Cover letter – Additional information

This document outlines the planned modifications to the Artemis sub-assemblies to assist with an application for a permissive change.

General Arrangement

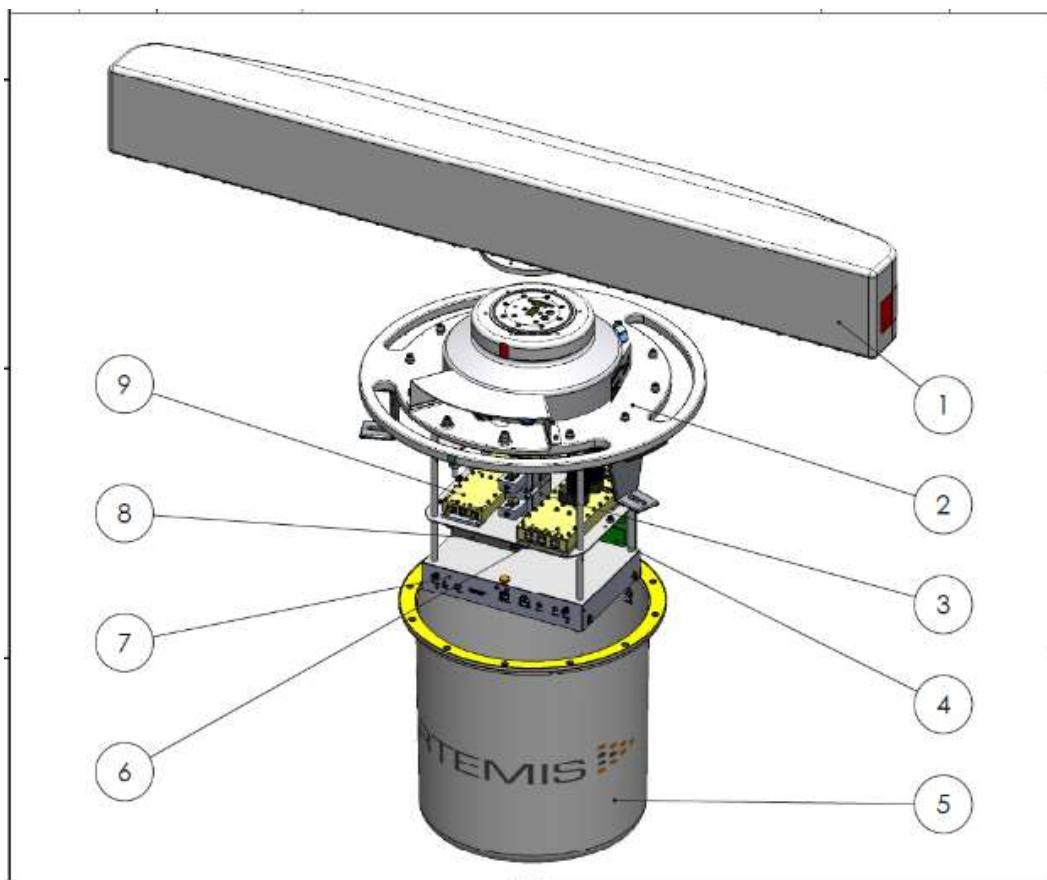
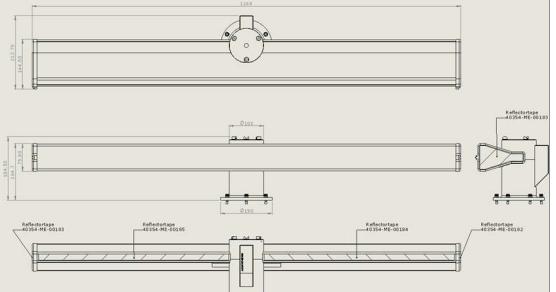
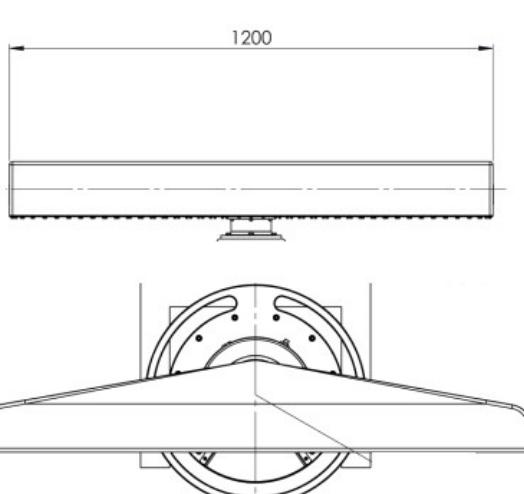
| General Assembly: Date of Grant -see Sec 10. | | | General Assembly: Proposed Modification-see Sec 11. (Shown in dwg above) | | |

| 20-0212-4 Artemis Mk6 Antenna | 21-0530 Artemis Mono-pulse Antenna Mk2 |

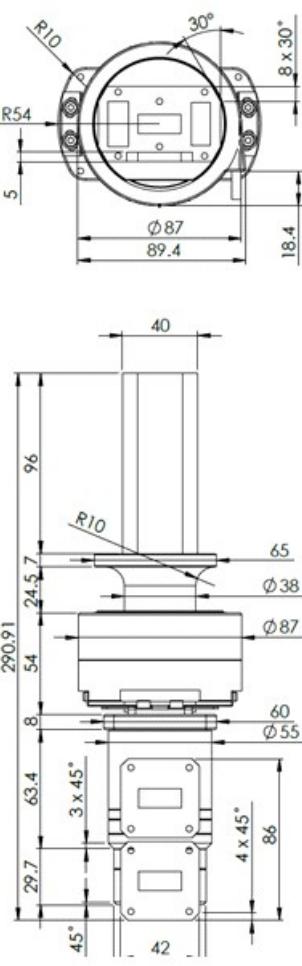
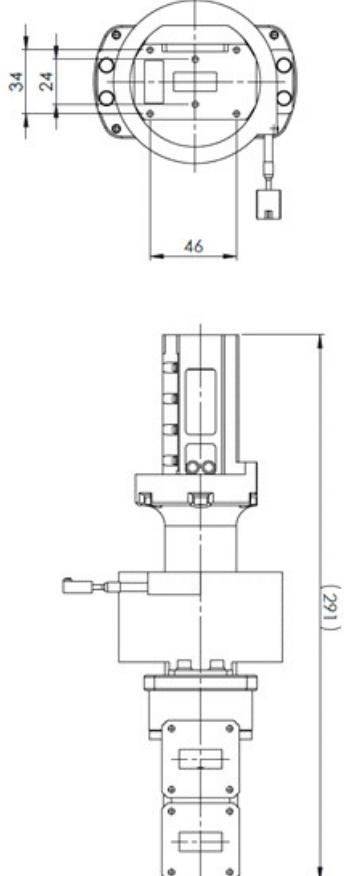
Reason for change of 20-0214-4 to 21-0530

Improvements to components and simplification of manufacture/assembly.

| <p>21-0420 = 21-0419+Flange</p> <p>21-0419 Rotary joint and Encoder (shown below)</p>  | <p>21-0559 = 21-0556 + Flange (21-0557)</p> <p>21-0556 Rotary Joint and Encoder (shown below)</p>  |

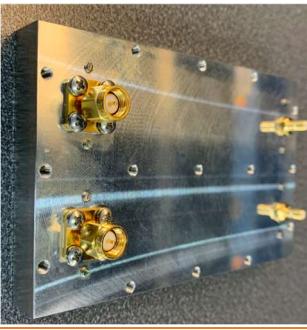
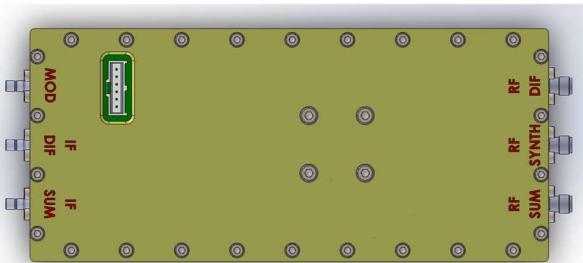
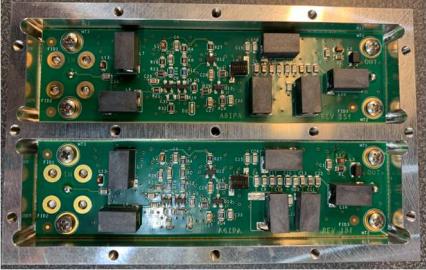
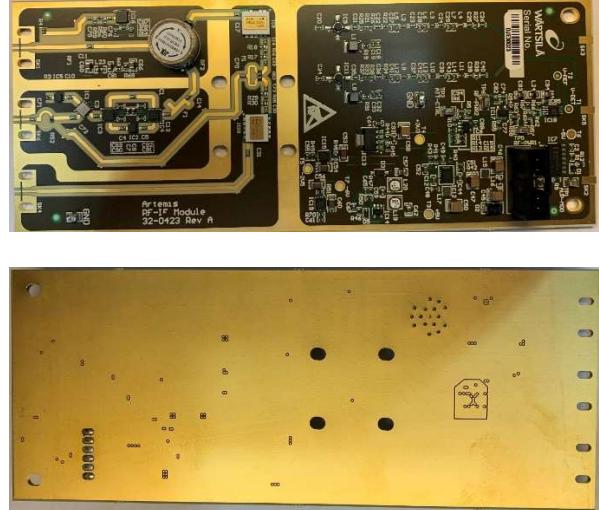
Reason for Change of 21-0240 to 21-0559.

Improvements to components and simplification of manufacture and assembly. All interfaces and fixings are identical

| 21-0433-3 Input pre-amplifier sub assembly | 21-0537 Solid-state RF-IF Assembly |

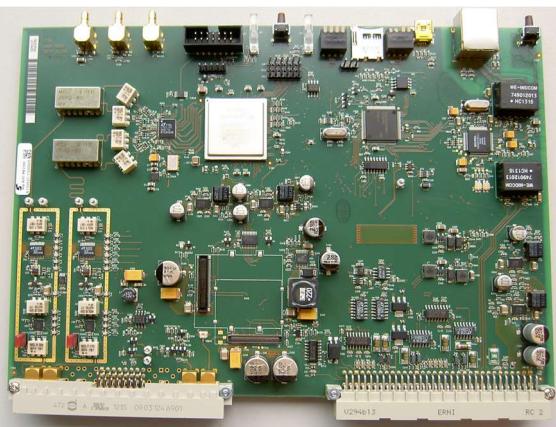
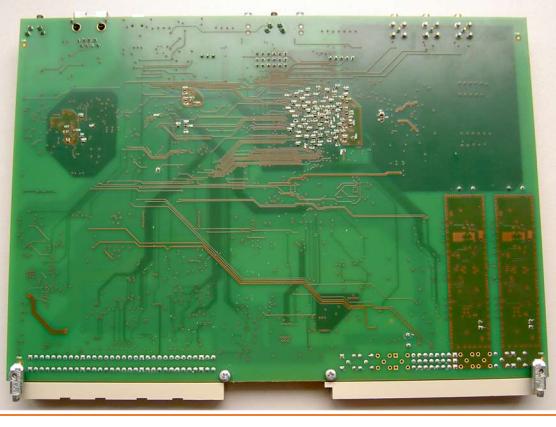
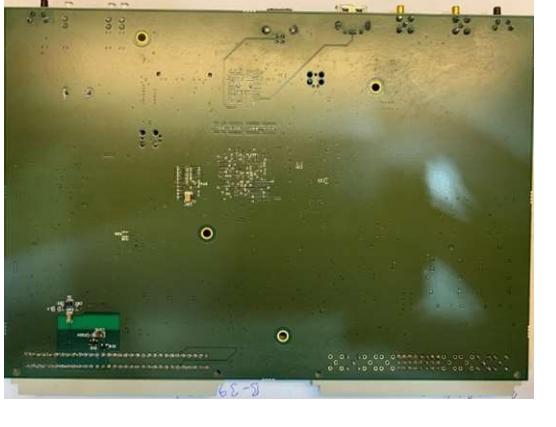
Reason for change

The 21-0433-3 Input pre-amplifier, which consists of waveguide circuitry has potential cost, supply and performance issues. Improvements can be gained from a solid-state electronics version. The assembly 21-0537 also has the benefit of amplifiers that have lower noise performance when compared to the waveguide circuitry.

| 21-0435-3 AUP Assembly 30-0337-4 PCB Front | 21-0517 AUP Mk2 Assembly 30-0414 PCB front and back |

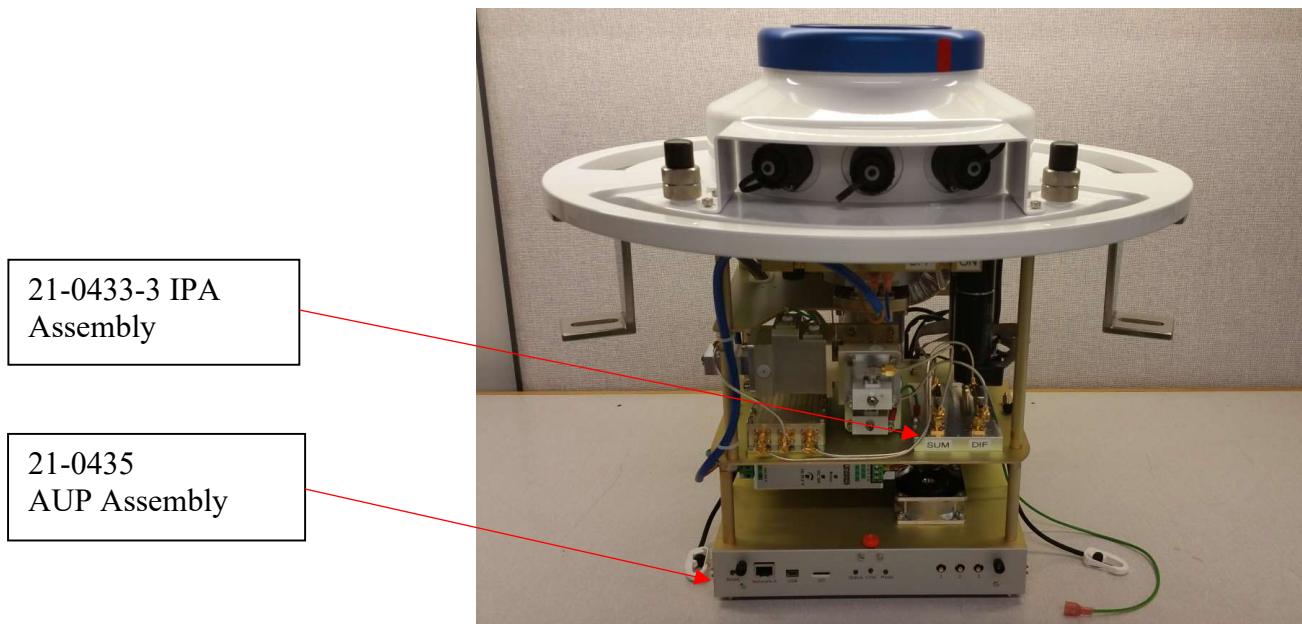
Reason for change

Component obsolescence, opportunity for streamline the design with updated electronic components

11. General Assembly: Proposed Modification

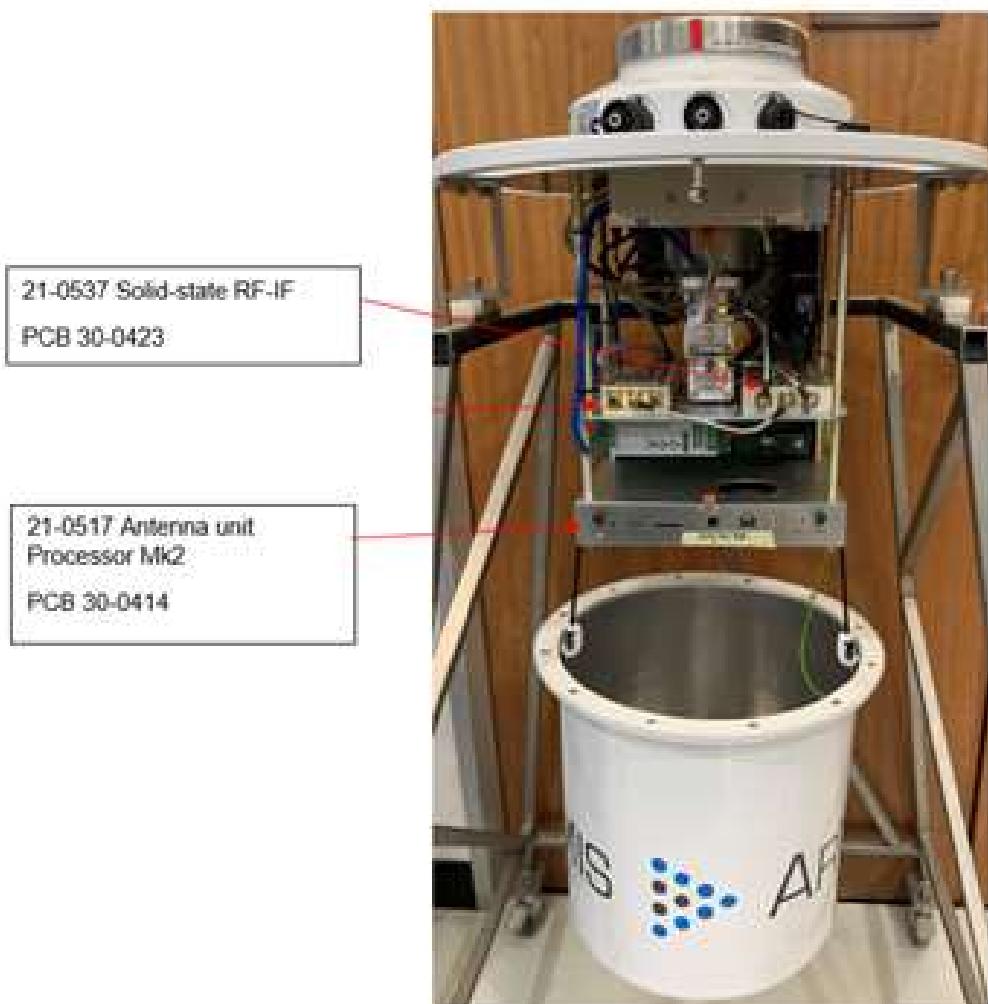
The General Arrangement with the modified sub-assemblies are shown in the picture below.
